Re: FortisBC Energy Inc. (FEI)

Application for Approval of a Certificate of Public Convenience and Necessity (CPCN) for the Okanagan Capacity Mitigation Project (OCMP) (Application)

Response to the Commercial Energy Consumers of BC (CEC) Information Request (IR) No. 1

Figure 3-1: 2023 Peak Demand Forecast

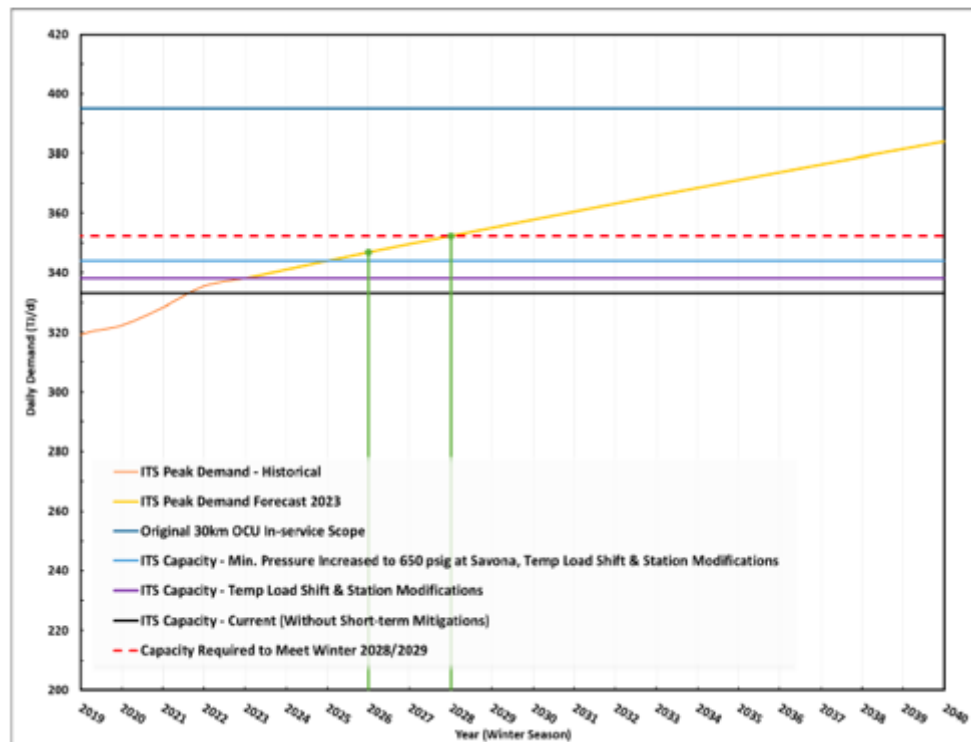
1. Reference: Exhibit B-1, page 11 and 12

1.1 Please explain when the most recent, 2023, Peak Demand Forecast was made, what years' data it was based on, and when FEI will have the next Peak Demand Forecast available.

5 FEI is currently in the process of completing the new peak demand forecast using the actual 2023
6 year-end data; as such, the 2024 peak demand forecast is not currently available. However, given
7 the 2023 actual year-end data show close alignment to the 2023 forecast, the 2023 Peak Demand
8 Forecast provided in the Application remains valid for forecasting the near-term peak demand.
